January 14, 2010
U7-C-STP-NRC-100018

South Texas Project
Units 3 and 4
Docket Nos. 52-012 and 52-013
Response to Request for Additional Information

Attached are the responses to the NRC staff questions included in Request for Additional Information (RAI) letter number 297 related to Combined License Application (COLA) Part 2, Tier 2, Sections 3.8.1 and 3.8.5.

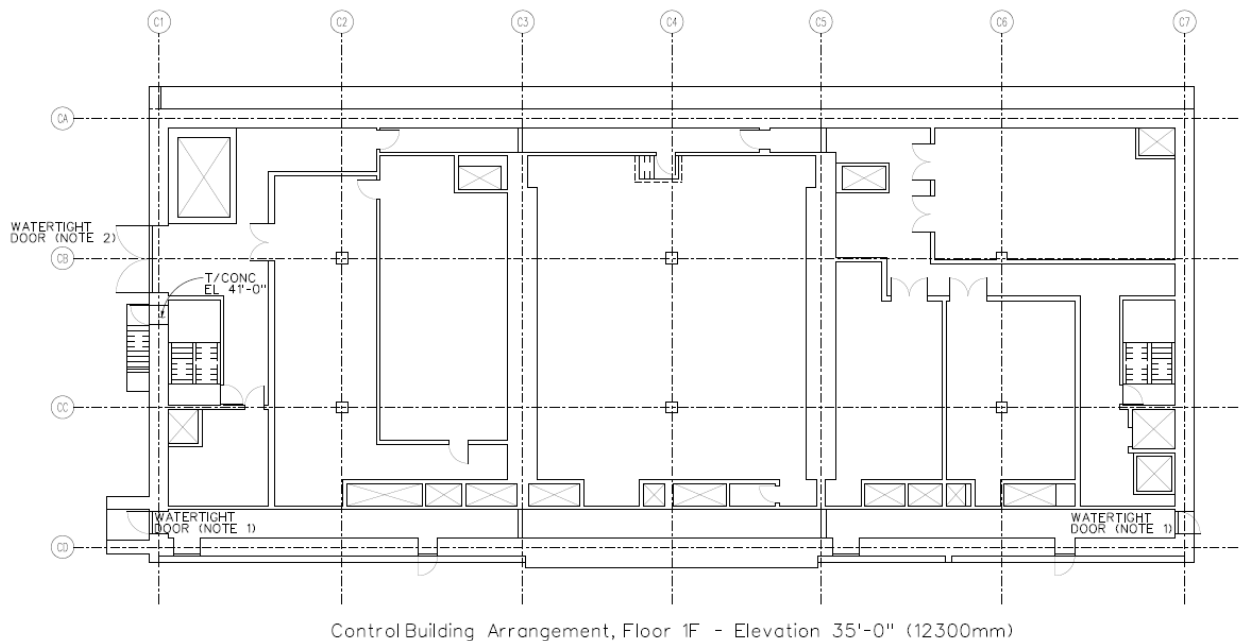
- (2) Identify the location of the additional watertight door between the Control Building and the Radwaste Building Access Corridor. This is not clear from the response to Question 03.08.04-3. Please identify the location of this door in a drawing.

- 1) COLA Part 2, Tier 2 Table 3.2-1 will be revised with a footnote added to the Reactor Building and Control Building rows to state that watertight doors which protect the safety-related equipment from an external flood are designated as Seismic Category I.
- 2) The attached sketch shows the additional watertight door between the Control Building and the Radwaste Building Access Corridor. Note that there is another exterior door by the stairwell shown on this sketch which does not need to be watertight because it will be located above the design basis flood level.

NOTES:
 1. WATERTIGHT DOOR NORMALLY OPEN.
 2. WATERTIGHT DOOR NORMALLY CLOSED.

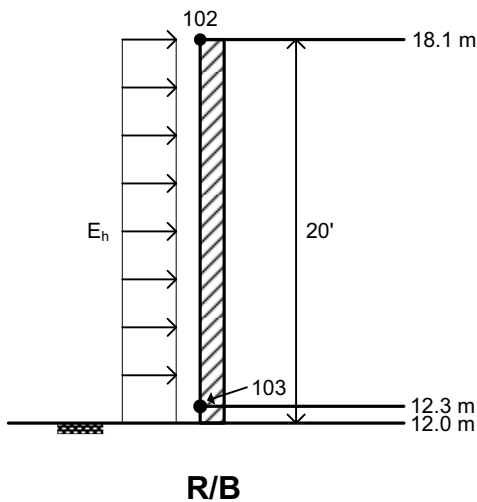
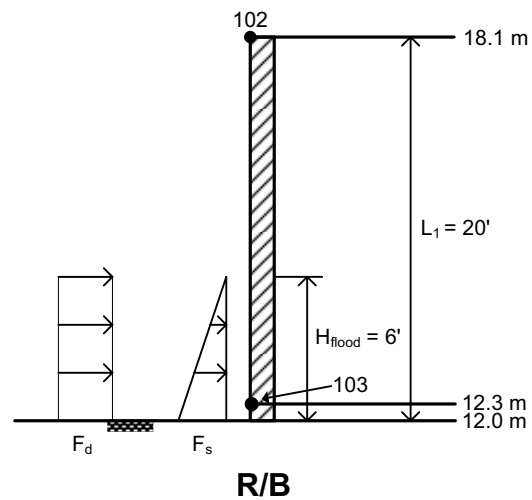
- (1) The applicant's response compares the out-of-plane shear and moment demands due to flood pressure with those due to the seismic load. The applicant did not include in its response any description or explanation about how the out-of-plane shear and moment demand for flood load and seismic load were obtained for the evaluation. Therefore, the staff requests the applicant to provide a detailed description of how the representative wall elements for the reactor building (RB) and the control building (CB) were selected for the evaluation, and how the reported shear and moment demands for flood and seismic load were determined.

(a) Reactor Building:

Seismic acceleration at grade level = 0.47g (Conservative, see DCD Table 3A-23a, rigid zone acceleration for node 103)

Simply supported wall span = 20 ft (see figure below, conservatively the span is assumed to be from grade to node 102, this will yield a more critical shear demand comparison)

Applied out-of-plane load = 150 x 4.3 x 0.47 = 303.15 lb/ft²

Calculated shear demand = 3.03 k/ft

Calculated moment demand = 15.16 k-ft/ft

Simply supported span = 20 ft

Flood height = 6 ft (above grade)

Water density = 62.4 lb/ft³Hydrostatic head at grade (F_s) = 6 x 62.4 = 374.4 lb/ft²Hydrodynamic load (F_d) = 44 psf (See response to RAI 03.08.01-4)

Calculated shear demand = 2.13 k/ft

Calculated moment demand = 5.44 k-ft/ft
